APPLICATION NUMBER

5488

**FRONT SETBACK, FRONTAGE LANDSCAPING, VEHICLE
STACKING AND PROTECTION BUFFER VARIANCES TO
ALLOW THE CONSTRUCTION OF A PHARMACY WITHIN 12.4'
OF A FRONT PROPERTY LINE, WITH LESS THAN 60%
FRONTAGE LANDSCAPING, LESS THAN THREE VEHICLE
QUEUEING SPACES PER DRIVE-THROUGH LANE CLEAR OF
DRIVE AISLES, AND NO VEGETATIVE PLANTING OR FENCE
BUFFER ALONG RESIDENTIALLY ZONED PROPERTIES IN A B-
2, NEIGHBORHOOD BUSINESS DISTRICT; THE ZONING
ORDINANCE REQUIRES A 25' FRONT SETBACK FOR ALL
STRUCTURES, 60% FRONT LANDSCAPING , THREE QUEUEING
SPACES PER DRIVE-THROUGH LANE CLEAR OF DRIVE
AISLES, AND A MINIMUM 6' HIGH WALL, FENCE, OR SCREEN
PLANTING BUFFER ALONG RESIDENTIALLY ZONED
PROPERTIES IN A B-2, NEIGHBORHOOD BUSINESS DISTRICT**

BOARD OF ZONING ADJUSTMENT

VARIANCE A SITE PLAN

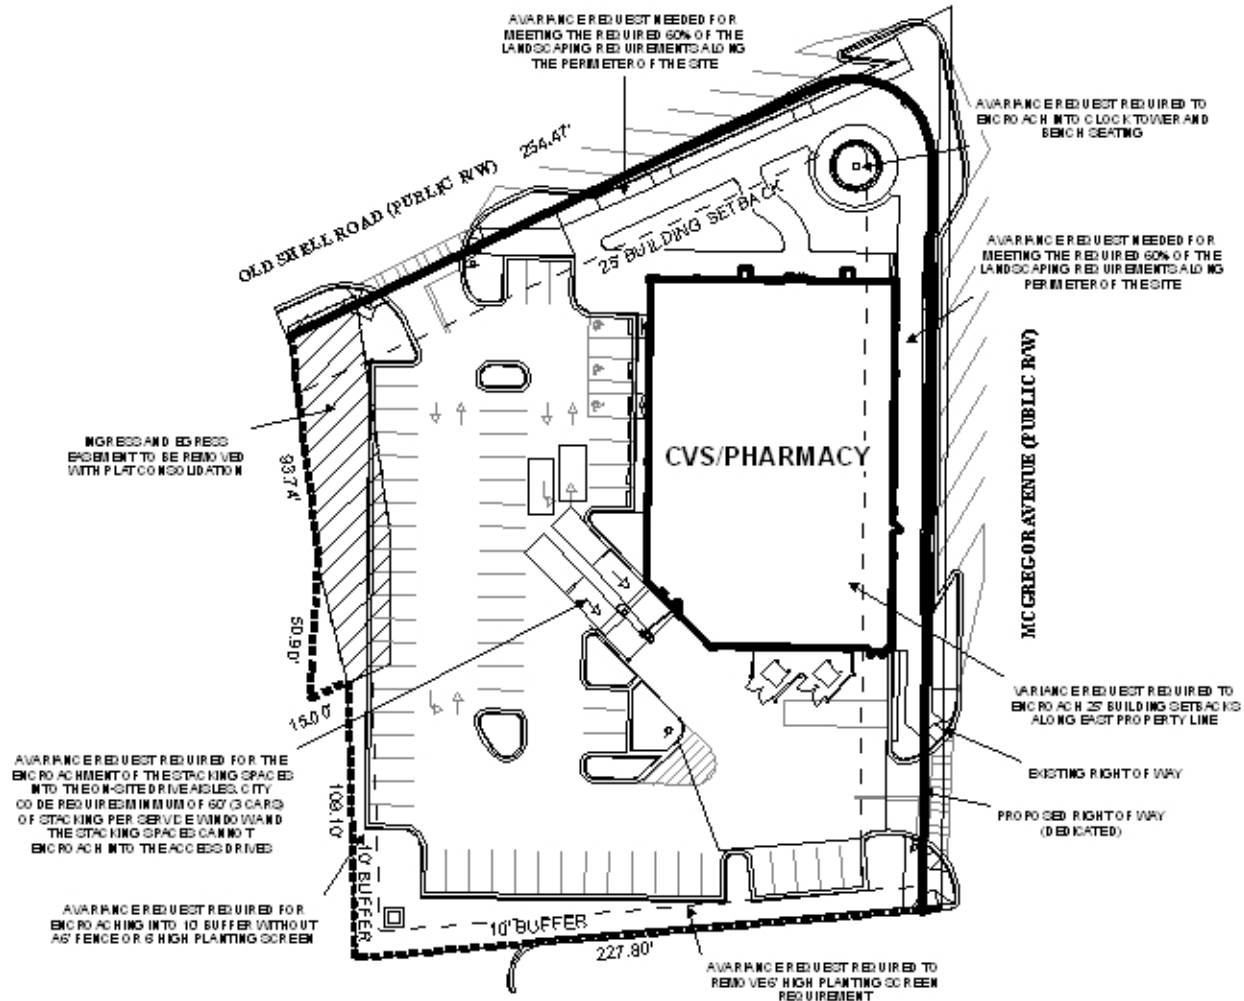
As previously noted the applicant submitted two different site plans, this report illustrates the request to reduce the setback along McGregor Avenue from 25-feet to 12.4-feet for the building, to allow less than the required 60% of the 12% (7.2 %) required front landscaping, less than three vehicle queuing spaces per drive-through lane clear of drive aisles, and no vegetative planting or fence buffer along residentially zoned properties in a B-2, Neighborhood Business District.

site would provide 23.7 % of landscaping on the overall site, but provides approximately 2,950 square feet of the required 4,893 square feet front landscaping. The applicant is requesting a variance to allow stacking as illustrated on the proposed site plan, which illustrates a two car queue; however, the two car queue does not impede vehicular movement within the site. Lastly, the applicant is requesting that the buffer requirement of the Ordinance to provide a minimum 6-foot high solid wooden fence along the property line abutting residentially zoned properties be waived. A small portion of the property adjacent to the site is zoned residentially; however, its use as a church is allowed in a residentially zoned district. The buffer would provide a buffer from the proposed commercial use and the church parking lot and would act as a barrier between commercial and residentially zoned property.

It should be noted that the proposed plan illustrates on-street parking which is not allowed by the Ordinance; therefore, parking within the right-of-way would not be allowed.

In this instance, the applicant has not illustrated that enforcement of the standard setback, front landscaping, queuing and buffer requirements would cause an unnecessary hardship for this type of business; however, the Board should consider this request for approval of the setback, front landscaping, and queuing variances as they are in compliance with the pending Overlay amendment. However, the buffer variance request should be denied.

Based upon the preceding, this application is recommended for approval subject to the following conditions: 1) full compliance with all municipal codes and ordinances; 2) the provision of a buffer where the site adjoins residential property; and 3) the parking design and queuing spacing to be approved by the Traffic Engineering Department.
